**Subject:** Official Plan Amendment Application OPA 20-002/P  
Zoning By-law Amendment Application A 06/20  
Director Industrial Holding Limited (Sorbara Group)  
Part of Lot 29, Range 3, Broken Front Concession  
(603 to 643, 645 and 699 Kingston Road)

## **1. Purpose of this Report**

**Submitted Conceptual Plan**

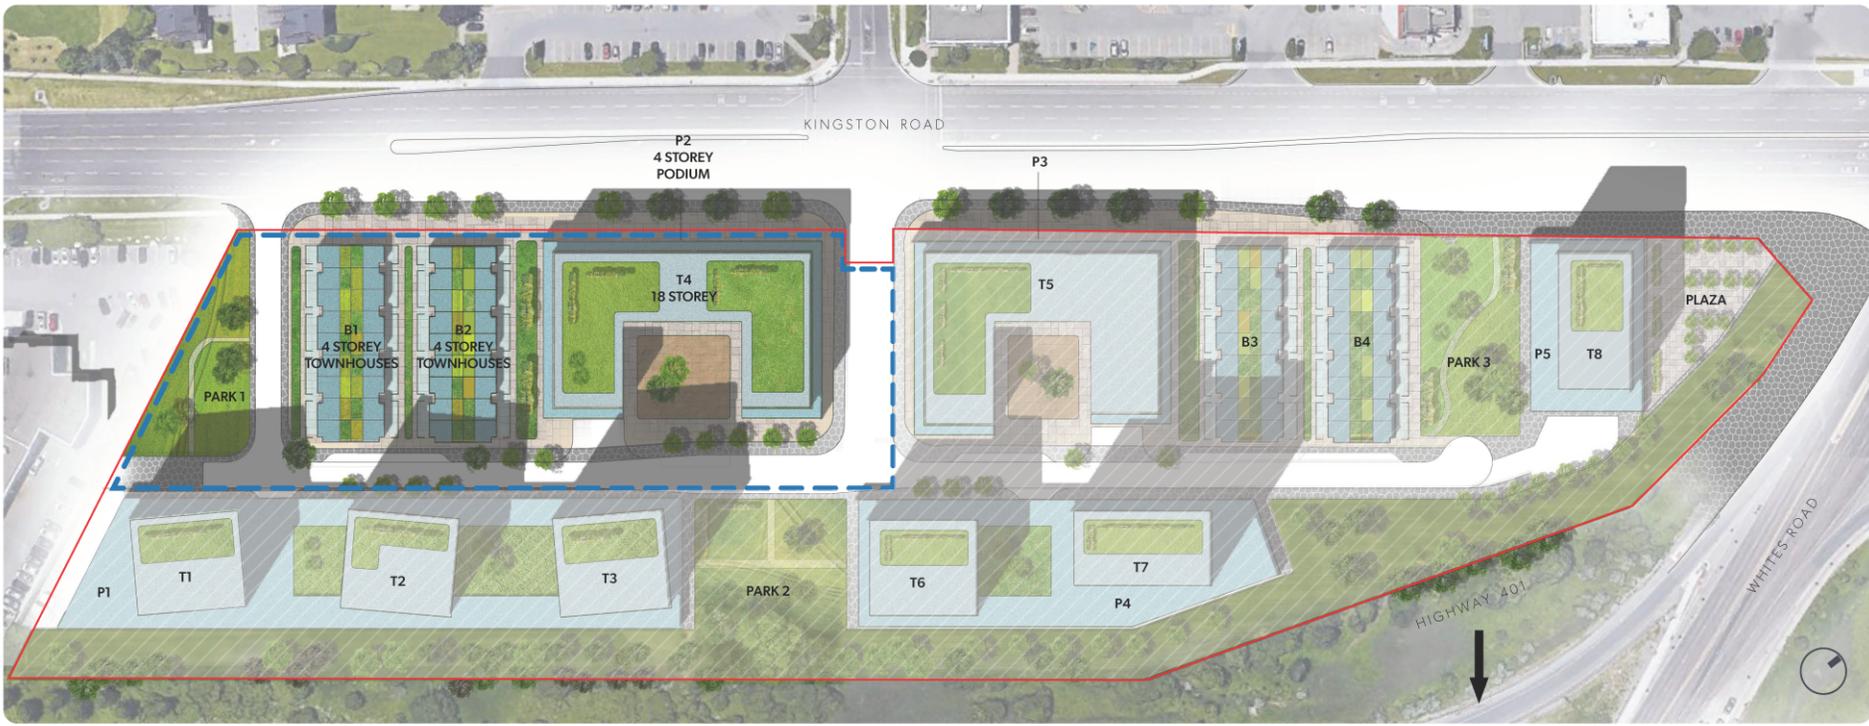
- the proposed plan shows a gateway plaza and three smaller park areas, two of which are encumbered with underground parking, stormwater management facilities and underground services. The third parkland area is quite small and irregular in shape. The preference would be to have one large central public park as shown in the Intensification Plan. The public parkland should not have any encumbrances (below-grade parking);

- the Kingston Road Corridor and Specialty Retailing Node Intensification Plan recommends a public road extending south from the intersection of Kingston Road and Steeple Hill through the subject site, extending west to connect back up with Kingston Road at a new signalized intersection on the east side of Petticoat Creek;

- the proposed access on the west side of the site is recommended to be restricted to a right-in-right out access only;
- the stormwater management criteria for all proposed developments within this area were updated after completion of the Kingston Road Corridor and Specialty Retailing Node Intensification Plan Study (December 2019). The current criteria for the proposed development require the control of post-development peak flow rates to pre-development levels, for all storms from 2-year up to and including 100-year event, using a maximum runoff coefficient of 0.5. These criteria should be applied to the proposed development, and the proposal should be revised accordingly;
